Explorative Carbon Footprint of Product Study for Nordic NMC811 and LFP Battery Cells

Battery Norway
11/07/2025

Table: Document details.

Table: Revision Details.

Figure ES-1: NMC811 cell cradle-to-gate comparative climate change impacts by region. Energy refers to the total electricity and natural gas consumption for precursor, active material, and cell production stages.

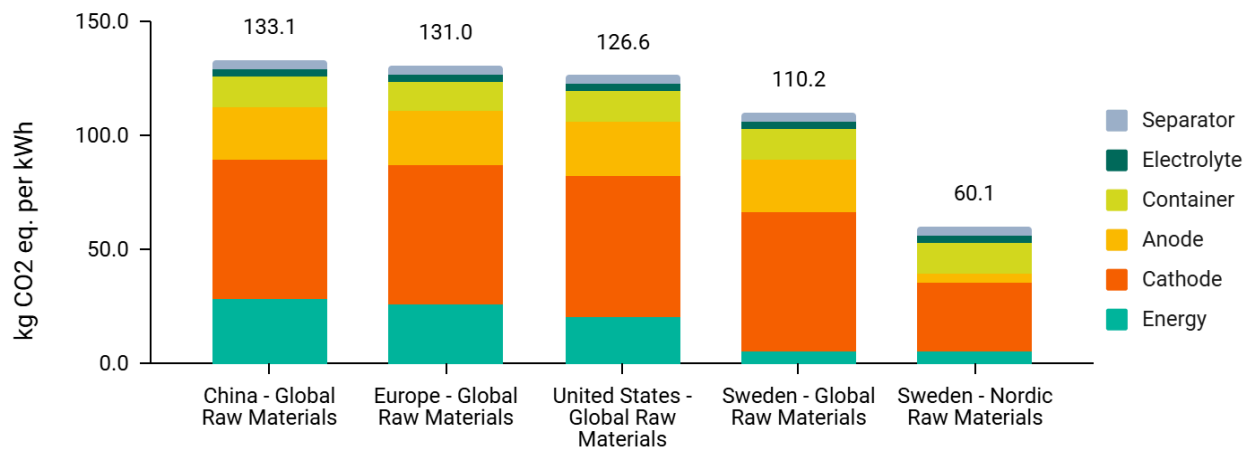
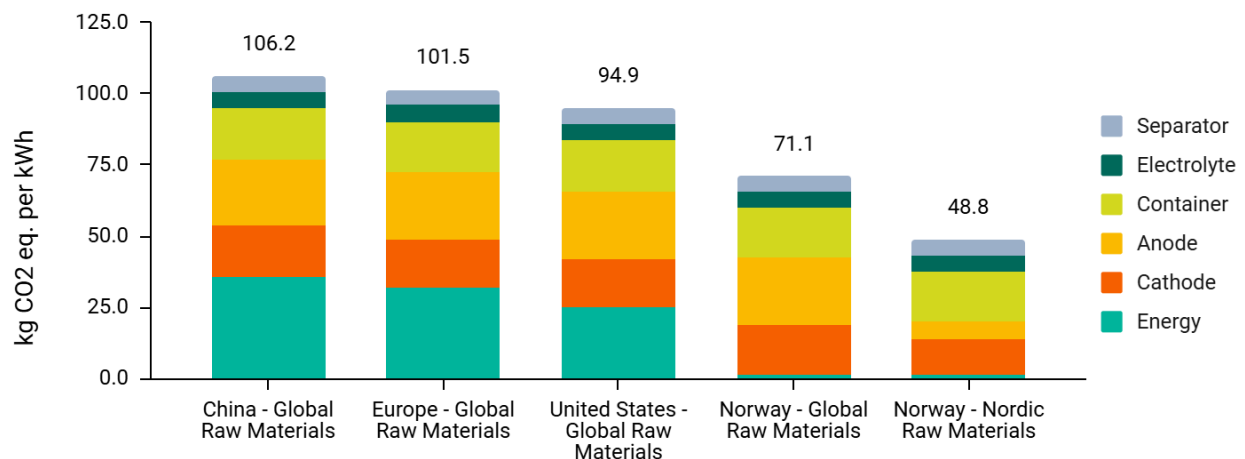
EC	EC2	5	Figure ES-1 and ES-2	Ed	Minor Few questions to these figures: - ES-1; Since recycling is analyzed separately and not included in the comparison, it would be helpful to specify the system boundary in the caption - Typo in "Seperator" - Does "Energy" refers to assembly electricity? As I assume downstream energy/electricity is included in the material (anode, etc.)	I would suggest: - adding "cradle-to-gate" in the caption - correcting the typo into "Separator" - specify in the legend "Assembly energy", "cell manufacturing energy" or something similar	[Revision] Added "cradle-to-gate" to both ES-1 and ES-2. Correct to "separator" throughout the report. Energy is kept for the legend for brevity; however we add the following to the figure caption. This has also been added to other relevant figures throughout the report. "Energy refers to the total electricity and natural gas consumption for precursor, active material, and cell production stages."

Figure 5: NMC811 cell total climate change impact by key component. Energy refers to the total electricity and natural gas consumption for precursor, active material, and cell production stages.

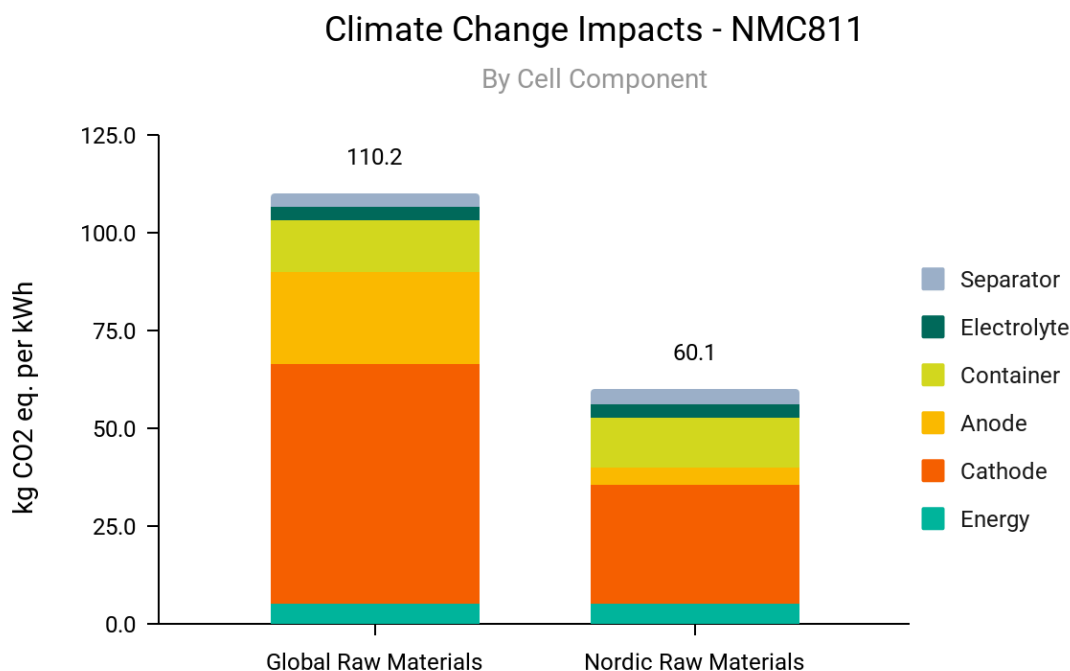
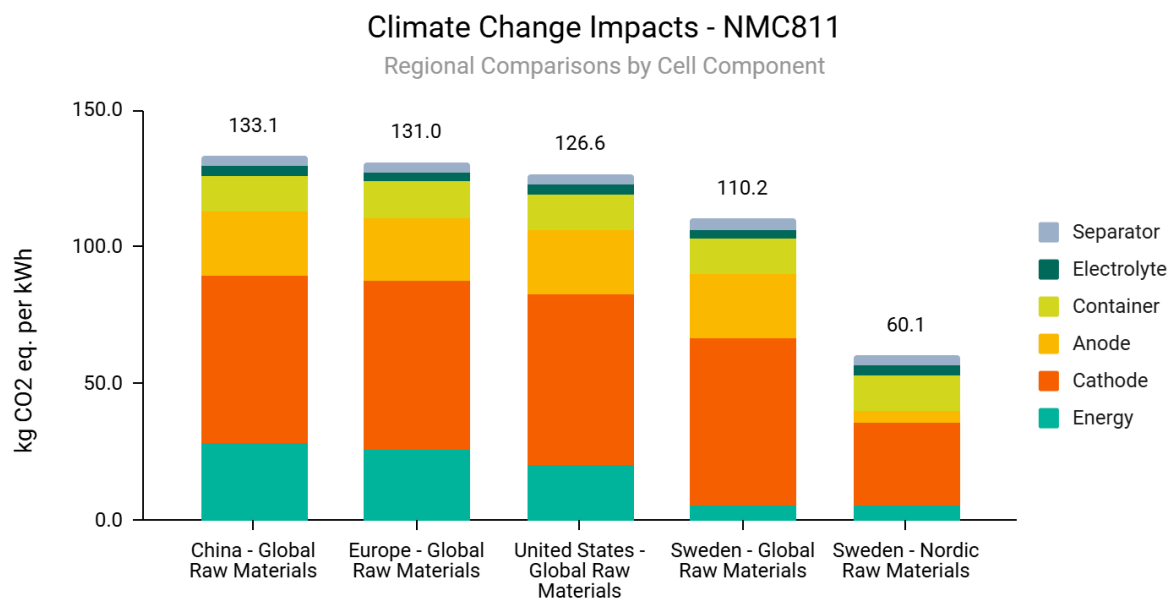
of the section		impacts of NMP solvent and aluminium foil, it would be useful to have % in brackets, as done for container		
EC	EC47	41 + 45	Figure 5 + 11	Ed	Minor Type - "Seperator"	Please, correct the typo	[Revision] Fixed
EC	EC48	41-42	Figure 6-7	Ed/Te	Major It is not very clear what contribution analysis by input means, because Ni, Co and Li are not inputs of the system as elements but mostly as sulfate or hydroxide. So what Ni, Co and Li represent here in the figures? the sulfates/ hydroxide for the precursor or an additional steps accounting for the % of element in the final electrode (and electrolyte in case of lithium as usually it is in form of LiPF ₆)?	Please, clarify in the caption and/or in the text	[Revision] Caption now clarifies this. <i>"For nickel, cobalt, and lithium, this corresponds to their sulfate and hydroxide precursor forms."</i>
EC	EC49	43	Figure 9	Ed	Minor Also here, contribution analysis by input can be misleading here, because what is represented here on the X axis are processes or production steps, which I guess include both inputs of energy and material, and outputs like waste and emissions.	Please, modify the caption or clarify the choice of wording	[Revision] Caption now clarifies this. <i>"This is inclusive of all energy and material inputs and outputs of waste and emissions."</i>

Figure 11: NMC811 cell comparative climate change impacts by region. Energy refers to the total electricity and natural gas consumption for precursor, active material, and cell production stages.

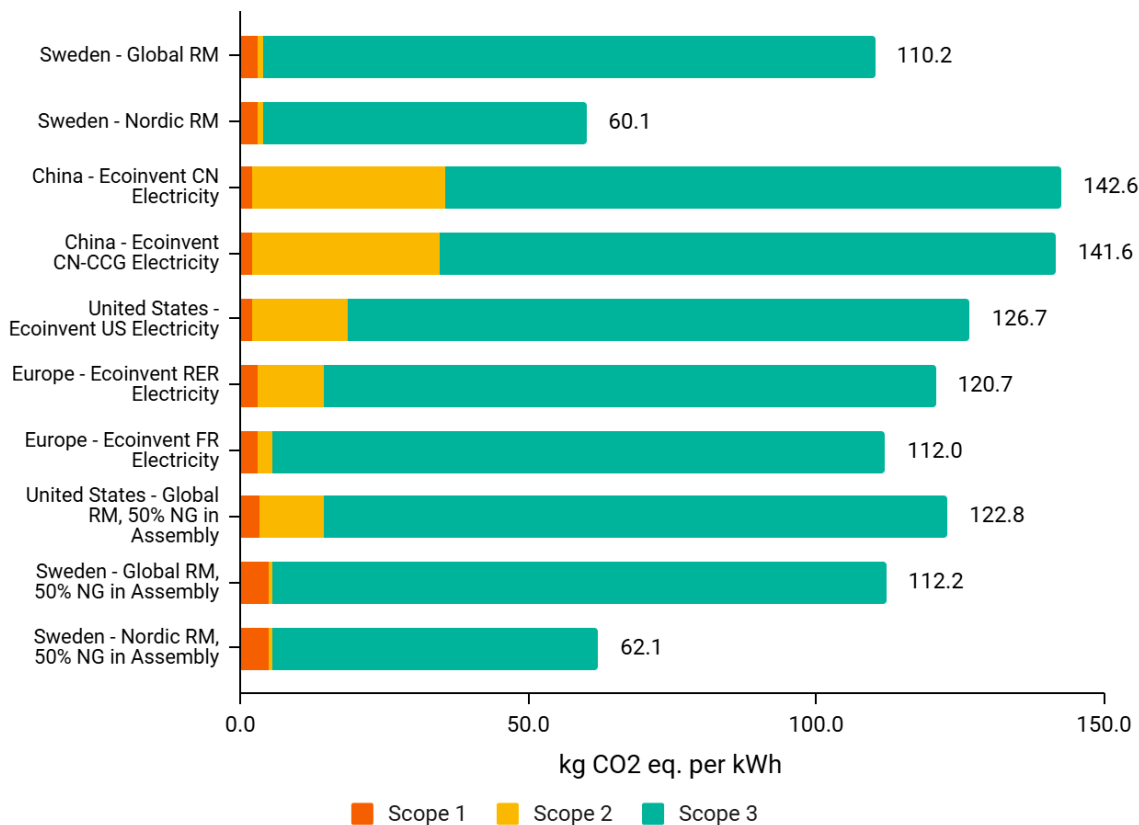
MC37	45	Figure 11	Ed	Generic	Why are some of these total values different from what is reported in figure 13?	<p>[Revision] Figure 13 is sensitivity testing of different background datapoints for the regions from ecoinvent and not the weighted averages we created.</p> <p>Table 17 in the sensitivity testing declared that different tests are done using different background datapoints to test our energy assumptions.</p> <p>We have also added the below: “These were separate selections from the weighted averages used in Table 7 for sensitivity testing declared in Table 17.”</p>
	MC38	45	Figure 11	Ed	Generic	Can you please verify the emission factor for China and EU. Seems like Chinese average is almost the same as EU average. Since that is the only differentiator in the figure i just want to be doubly sure.	<p>[No changes] That is correct, this is because manufacturing in Poland drive up the coal in the EU mix and inclusion of more hydro in China drives down the carbon intensity. Hence, these and the US one end up being very similar all round.</p>

Figure 15: LFP total climate change impacts by key component. Energy refers to the total electricity and natural gas consumption for precursor, active material, and cell production stages.

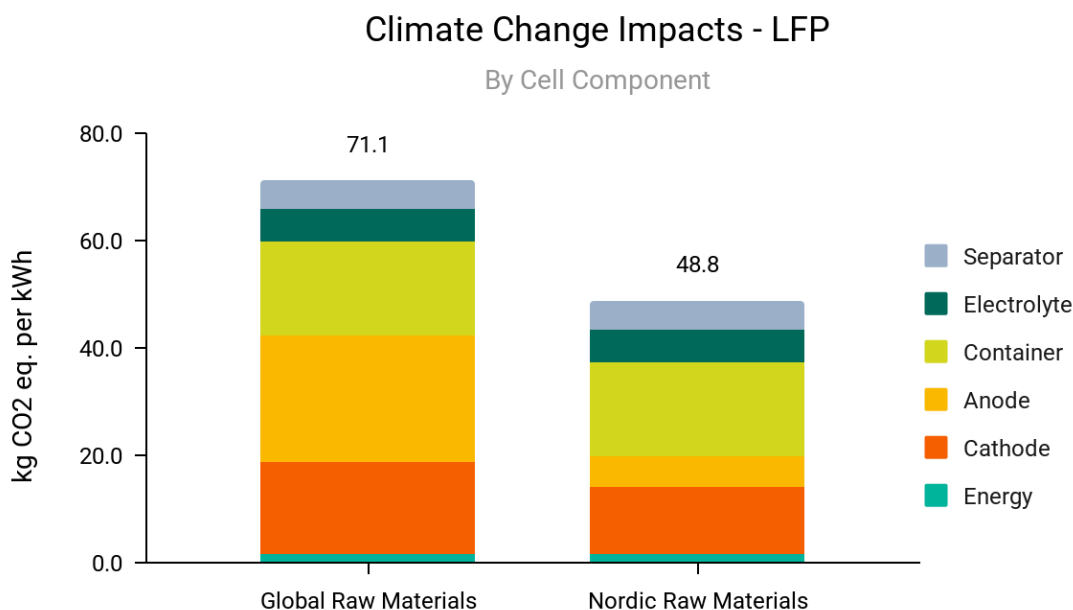
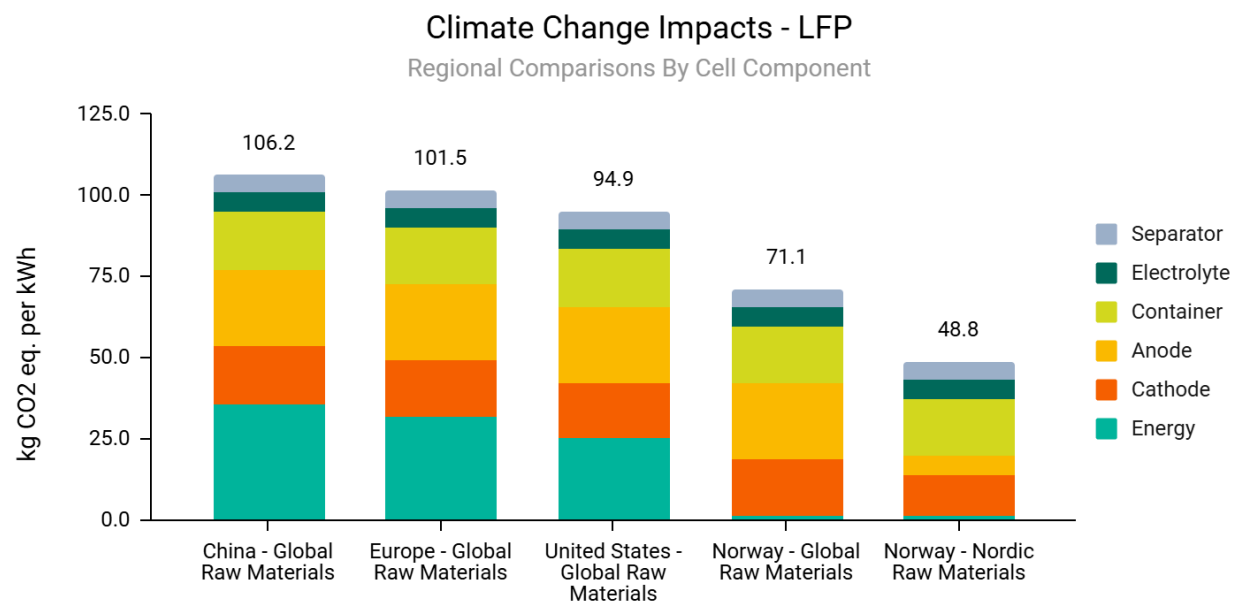
EC	EC51	49 + 51	Figure 15 + 18	Ed	Minor Type - "Seperator"	Please, correct the typo	[Revision] Fixed
EC	EC52	49	Section 3.3.1	Te	Major It is stated that "the cell container is the single largest contributor, accounting; however, the cathode follows -I'd say- closely with 24% after the 37% of cell container.	Please, clarify and if needed rephrase	[Revision] The sentence has been rephrased to remove "single". <i>"However, the cell container is the largest contributor,"</i>
EC	EC53	52	Section 3.3.4	Ed	Concerning the sentence "Specific data was collected for graphite and lithium" – please see comment EC50	Please, clarify this sentence	[Revision] Sentence has been amended since "specific" was not required. <i>"Data collected for graphite and lithium achieved good to very good DQRs (Table 17),"</i>
EC	EC54	54	Section 3.4	Te/Ed	Major A limitation should be stated here, with reference to the extra analysis in Appendix on including the use phase (so to give this analysis a more added value) : different use scenarios due to different applications and cell properties like life lifetime might lead to different results on a cradle-to-grave than on a cradle-to-gate boundary.	Please, adjust the text accordingly	[Revision] Additional text was added, please see RAS39 for full response.

MC47	51	Figure 18	Ed	Generic	I came across a report stating that China has added more renewable energy capacity than any other country last year. Obviously its possible only for a country that size. But this also means we need to check our assumptions about the grid mix once, just to make sure we are not completely off. The reason i bring this up now, is that I realize that the difference between China and EU is very minimal, and US is not too far off. So it could be that with latest additions to the grid, the outlier is no longer China.	<p>[Revision] This is a great point, and our baseline estimate calculated was around 680 g CO2e per kWh based on the regional battery productions (instead of the ecoinvent national average which is closer to 1000 g CO2e I believe which is way off).</p> <p>Looking at the most latest intensities reported, I think our estimated value is also in the ballpark</p> <p>I have also added this as a general limitation below.</p> <p><i>“Lastly, average electricity mixes are likely to change over time in response to current and future trends in energy generation capacity.”</i></p>

Figure 16: LFP contribution analysis by input for global raw materials.

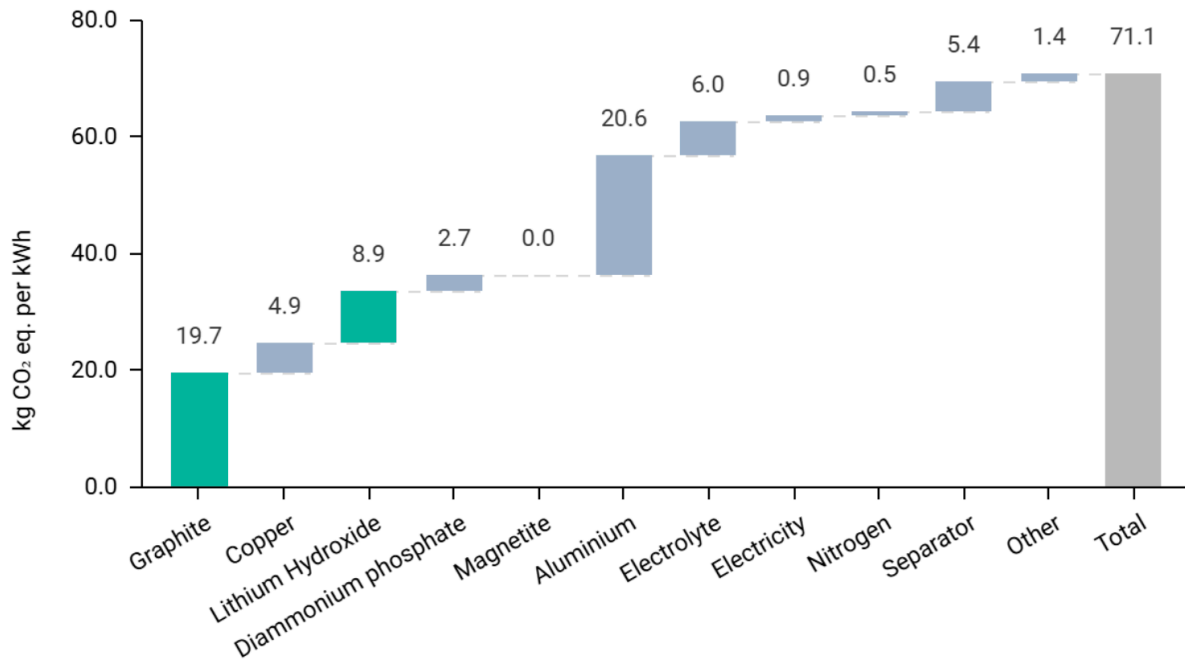
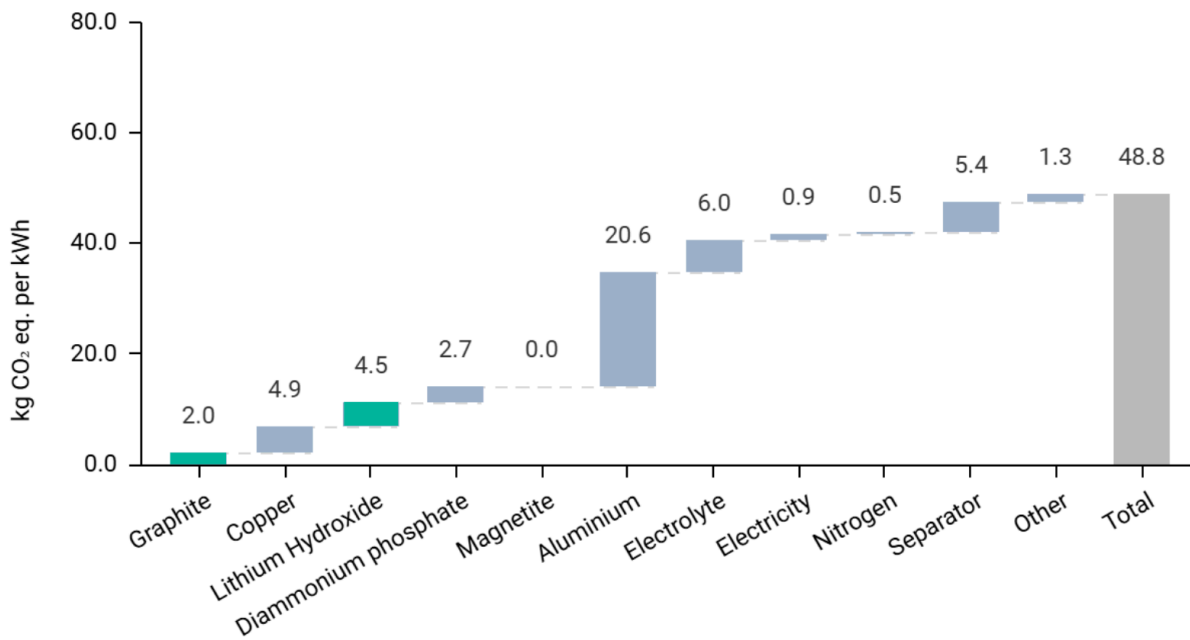
MC45	50	Figure 16	Ed		Same comment as what I had for the NMC811 part. You can make Figure 16 and 17 easier to read by identifying what impacts are different between Global and Nordic routes. If magnetite is so low, isnt it better to include it in others... ? Wasnt this the part of the cut off criteria?	[Revision] This has now been implemented. Magnetite is included as separate for reference because it is a key precursor to LFP.
	MC46	51	Section 3.3.2	Ed	“resulting in a grid carbon...”	per kWh of electricity generated.	[Revision] Corrected

Figure 19: LFP sensitivity analysis of the top 5 climate change impact contributors.

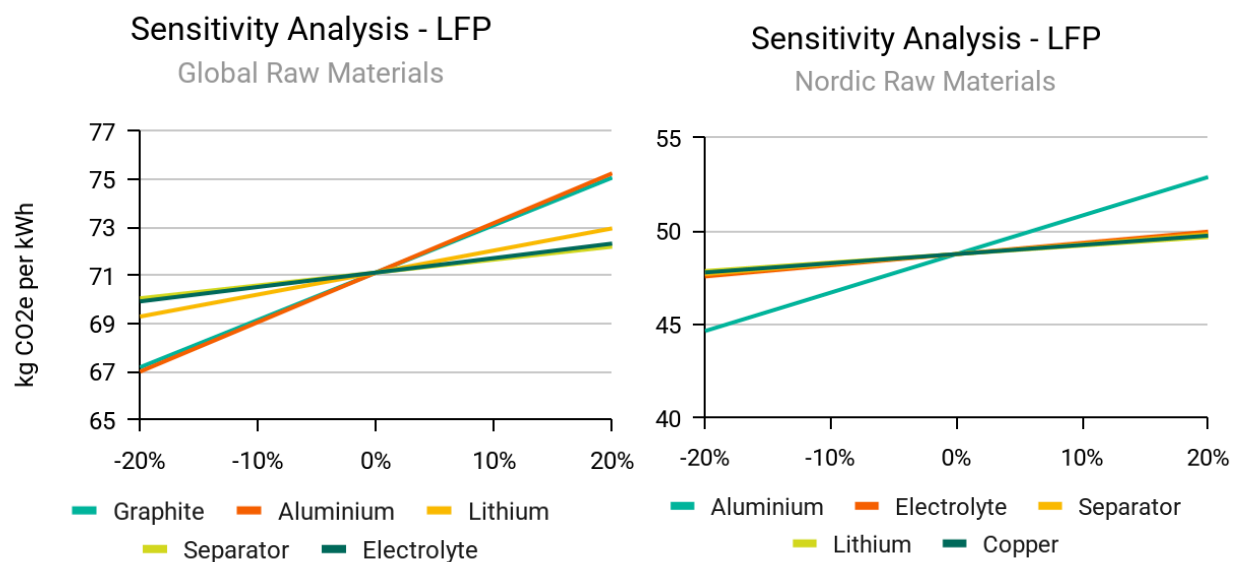
MC48	51	Section 3.3.4	Ed	Generic comment on sensitivity analysis	Here too, like the NMC811 case, I am not able to figure out how is this adding value. We need to discuss this a bit in our meeting next time.	[No changes] Responded in MC39
	MC49	53	Section 3.3.4	Ed	“... since no natural gas is used for ...”	Is it also correct to say, “... and no data for site related emissions is available.. ?”	[No changes] I can confirm that the original sentence is correct; no natural gas is used for manufacturing by Morrow.
	MC50	53	Figure 20	Ed	Comments on the final values reported in the figure.	<p>120 - Why is this result for China different from the result in Figure 18, where it is 106?</p> <p>95.1 - Almost the same value as it is in Figure 18, but shouldnt it be exactly the same?</p> <p>86.6- Big difference here again. Am sure there is an explanation and I havent followed it in the text.</p>	<p>[Revision] This should be addressed and clarity provided in the following responses:</p> <ul style="list-style-type: none"> - MC21: For energy value justifications. - MC41: Explaining why the numbers are different since its alternative sensitivity assumptions.

Figure 22: NMC811 vs LFP climate change impacts by key component. Energy refers to the total electricity and natural gas consumption for precursor, active material, and cell production stages.

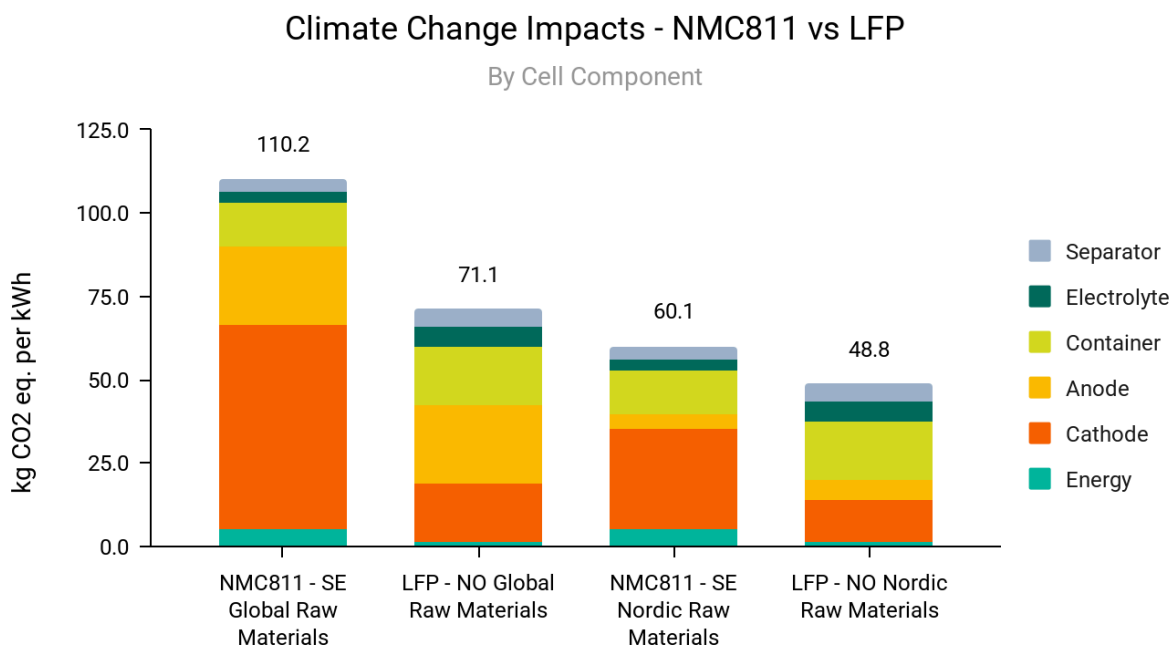
EC	EC55	55	Figure 22	Ed	Minor Type - "Seperator"	Please, correct the typo	[Revision] Fixed
EC	EC56	55	Section 3.4	Ed/Te	Major The sentence "Therefore, LFP and NMC811 have more competitive impacts in this case", should probably be about LFP having more competitive impacts. Additionally, this sentence is valid if the technologies are used in the same applications, over the same lifetime. Differences in the EoL e.g. possibility	Please, double check the sentence and correct it accordingly. Consider including the additional limitation.	[Revision] This has been amended, please see RAS40 for full response/change.
